**SUBJECT: NEW VEHICLE DEMONSTRATION / DELIVERY HOLD
Customer Satisfaction Program 20B34
Certain 2020 Model Year Explorer
Transmission Oil Cooler**

CERTAIN 2020 MODEL YEAR EXPLORER VEHICLES — TRANSMISSION OIL COOLER REPLACEMENT

FIGURE 1

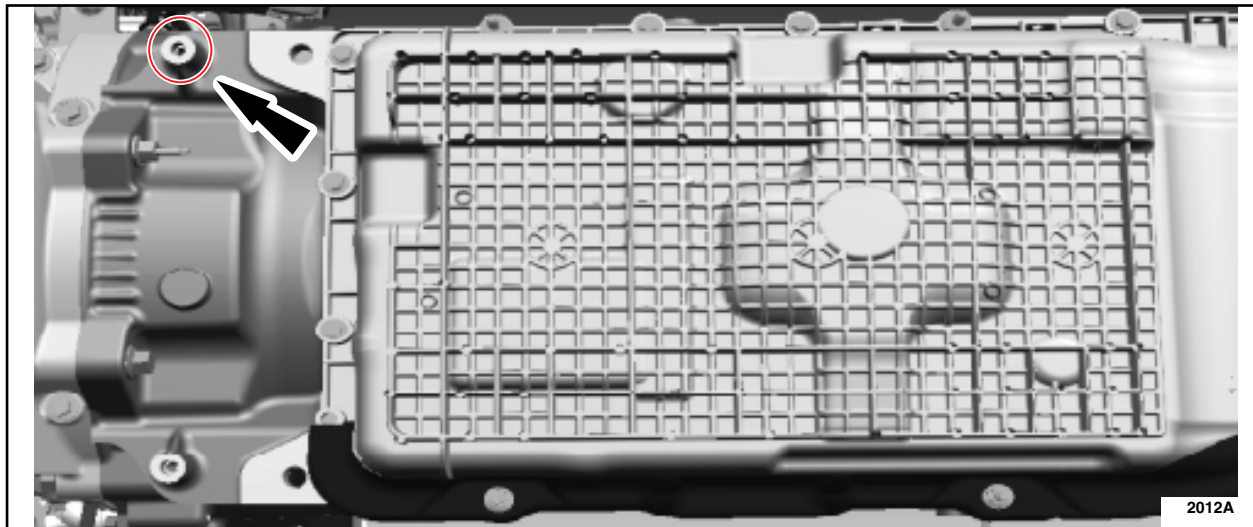
1. Replace the transmission fluid cooler. Refer to Workshop Manual (WSM), Section 307-02.
2. Install the M8x30 bolt. Torque to 25 Nm (18 lb-ft). See Figure 1.
